NHT Pro		
Title M20 Digital Meter (same as C20 rev C)		
Size	Document Number	Rev A
Date	Thursday, July 14, 2005	Sheet 1 of 1

NHT Pro		
File		
M20 Power Amplifier (modified from C20 rev C)		
Size	Document Number	Rev A
Date: Thursday, July 14, 2005 Sheet 1 of 1

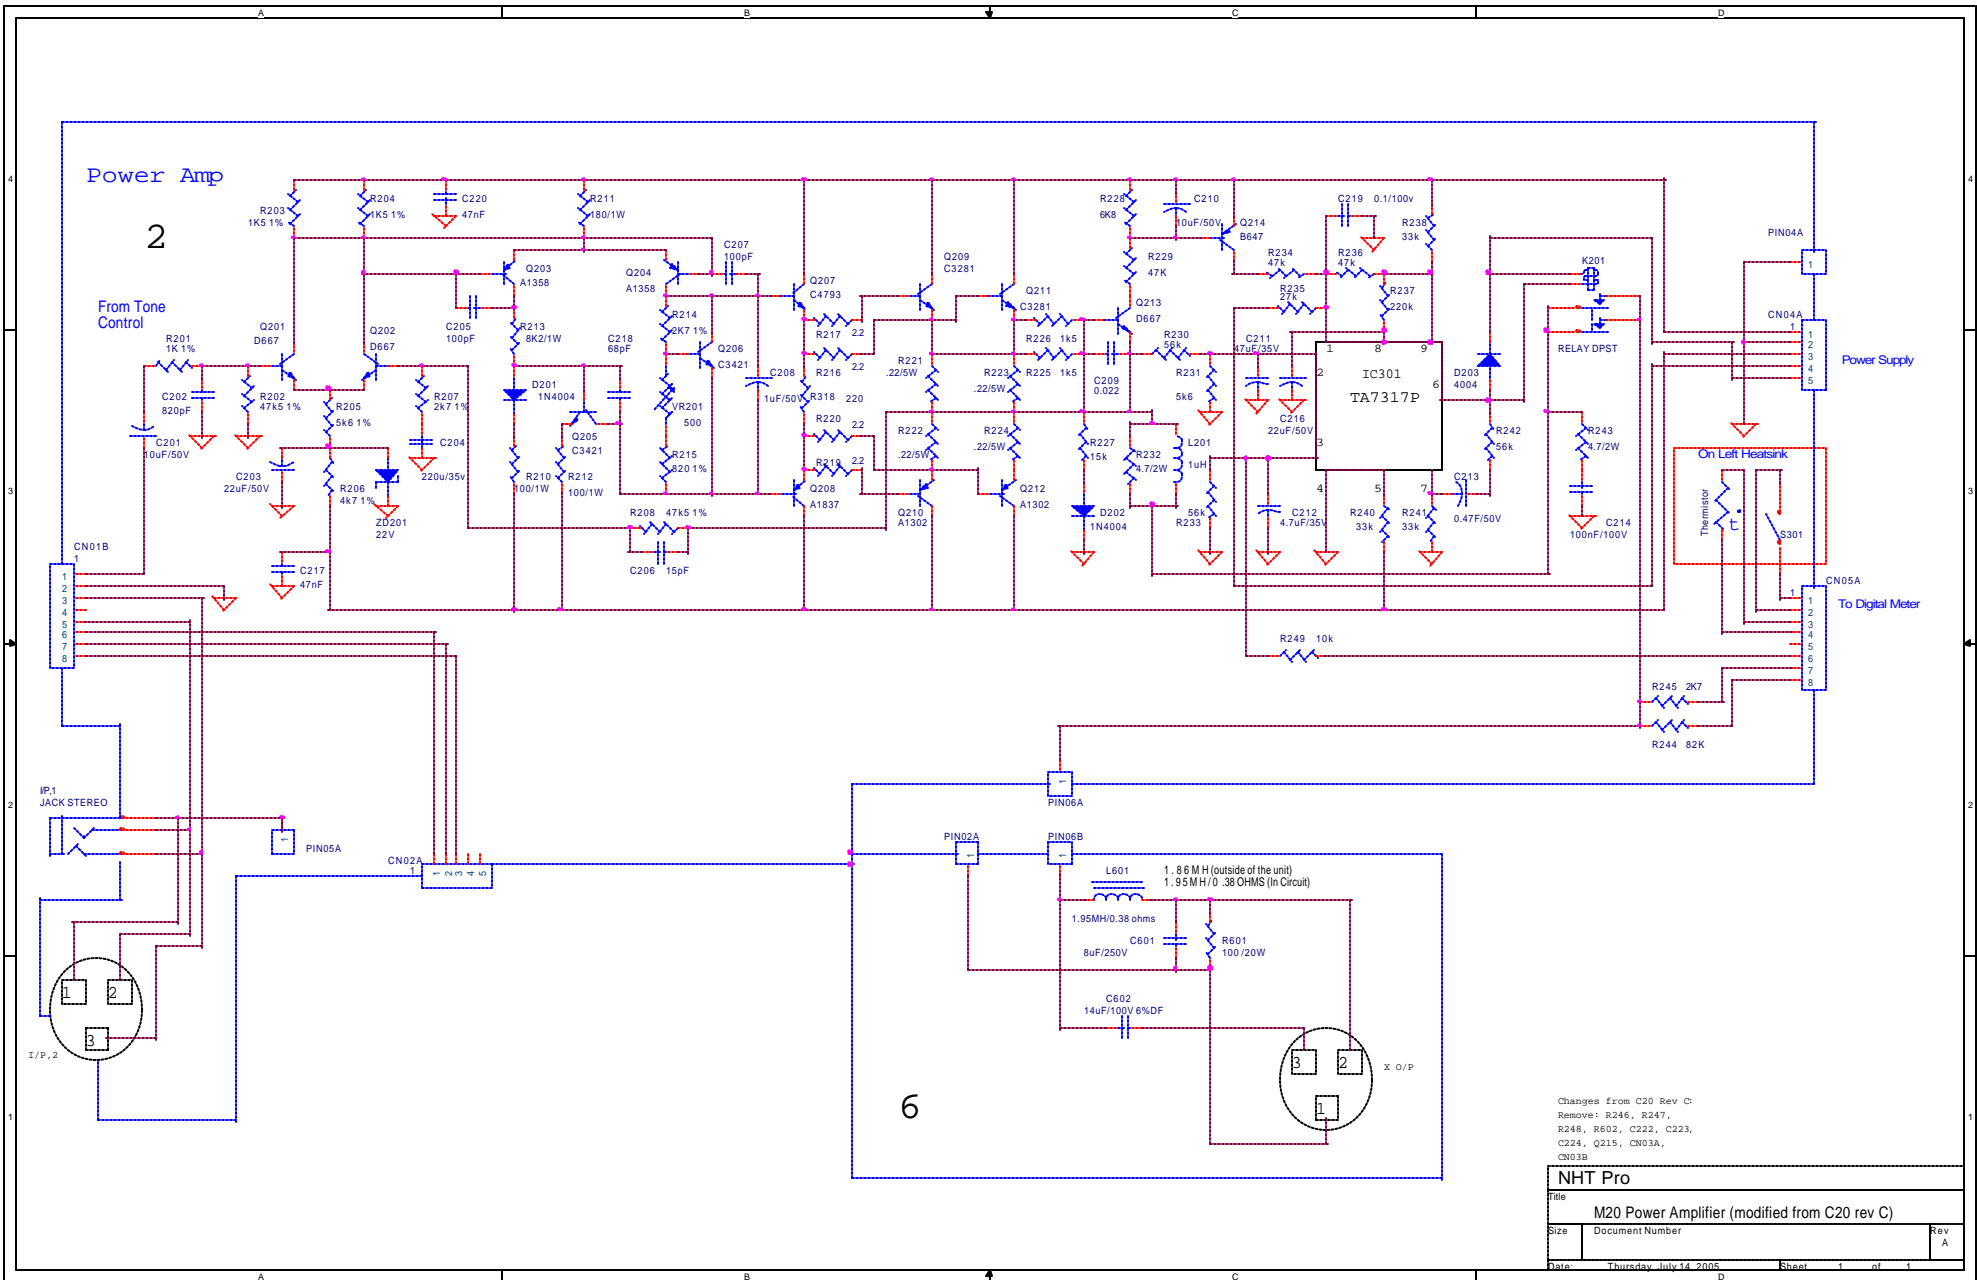
Changes from C20 Rev C
 Remove: R246, R247,
 R248, R602, C222, C223,
 C234, Q215, CN03A,
 CN03B

NHT Pro		
Title		
M20 Power Supply (modified from C20 rev C)		
Size	Document Number	Rev A
Date:	Thursday, July 14, 2005	Sheet 1 of 1

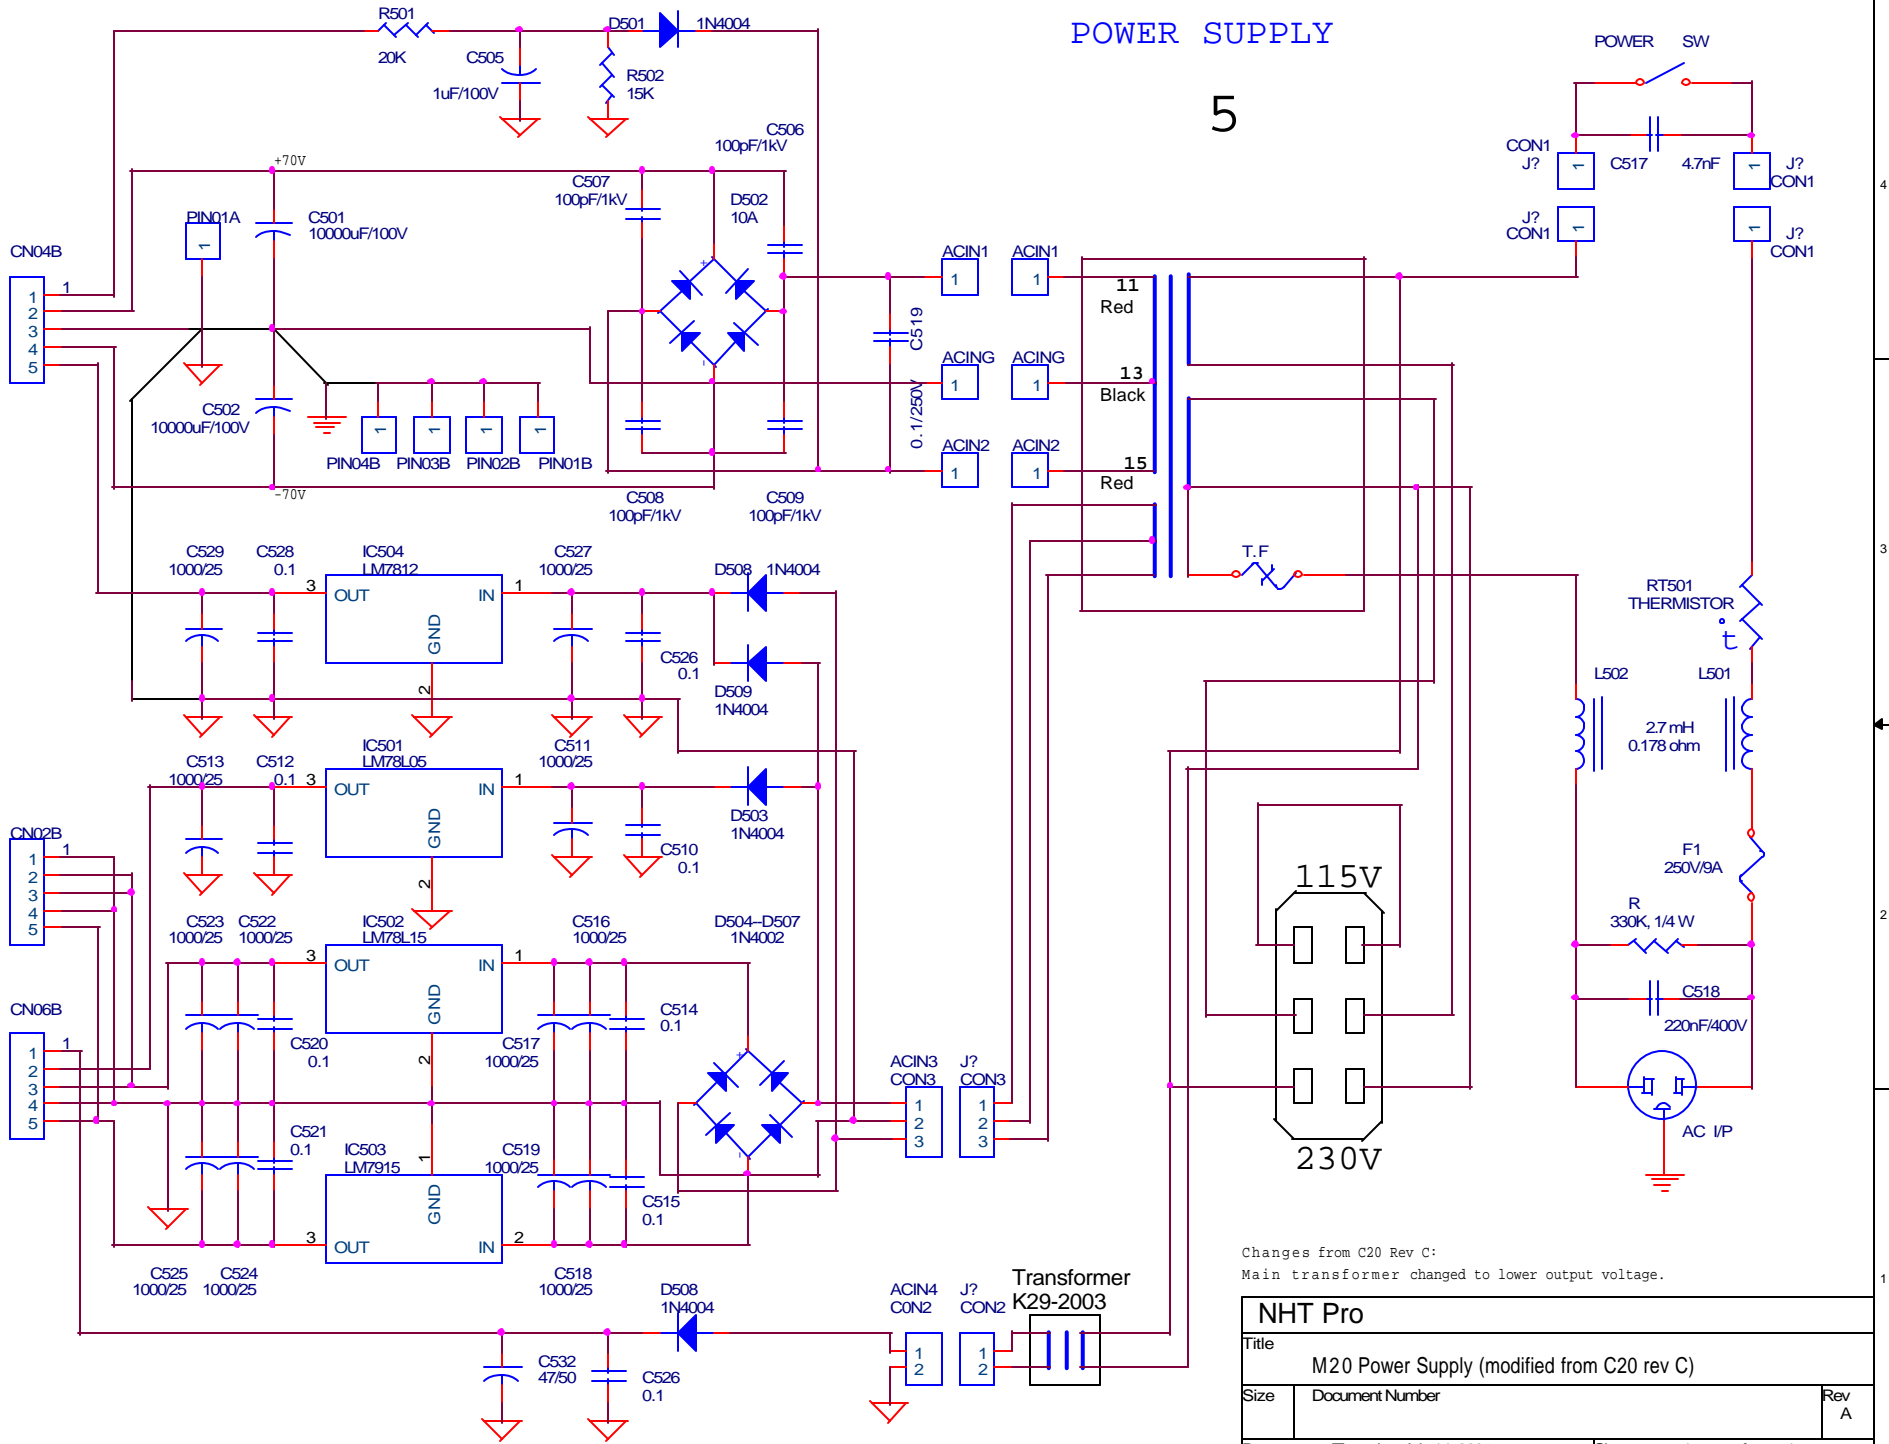
Changes from C20 Rev C:
Main transformer changed to lower output voltage.
